TO: Mercedes-Benz Dealer Principals, General Managers, Sales Managers, Service Managers, Parts Managers	FROM: Thomas Brunner, Department Manager, Vehicle Compliance and Analysis, Engineering Services
RE: <b>Recall Campaign with Retail Hold 2017050014 MY17 213 (E-Class) Rework Roof Spoiler</b>	DATE: May 26, 2017

Campaign No. 2017050014, May 2017

SUBJECT: **Model 213, Model Year 2017**  
**Check Roof Spoiler for Proper Fastening, Replace as Necessary**

Picture 1 **OK**

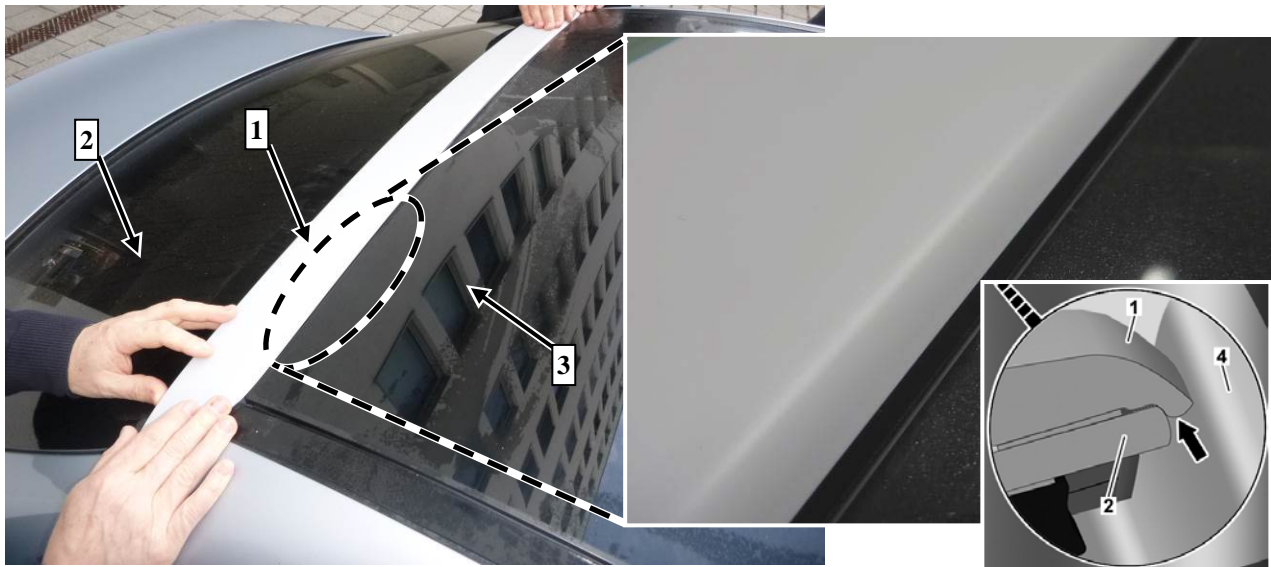
1. Check proper fastening of roof spoiler (1) to the rear window (2) (picture 1).

**i** The edge (enlarged detail, arrow, picture 1) attached to the roof spoiler (1) **must** be in contact with the rear window. The glass edge of the rear window (2) **must not** be visible from above.

Picture 2 **Not OK**

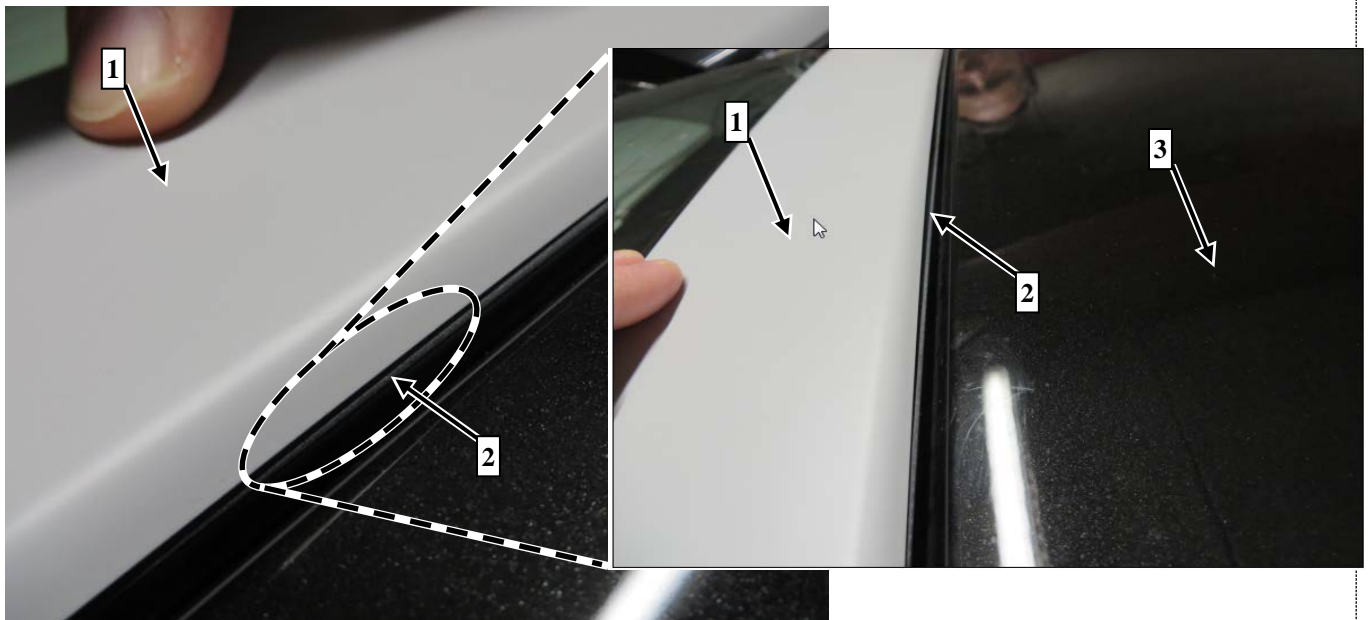
Picture 2 shows a **not OK** state. The roof spoiler (1) **must** be in full contact with rear window and bonded completely. To check the roof spoiler, lightly lift it toward the vehicle roof (3) by hand.

- If roof spoiler is **not** fastened correctly (**not OK**): Proceed to Subject B.
- If roof spoiler **is** fastened correctly (**OK**): Procedure is complete.

1. Replace roof spoiler: Refer to WIS: AZ88.30-P-0015LWE.

**i** **Note**:-To disassemble the roof spoiler, use plastic wedge. Completely remove adhesive residues.
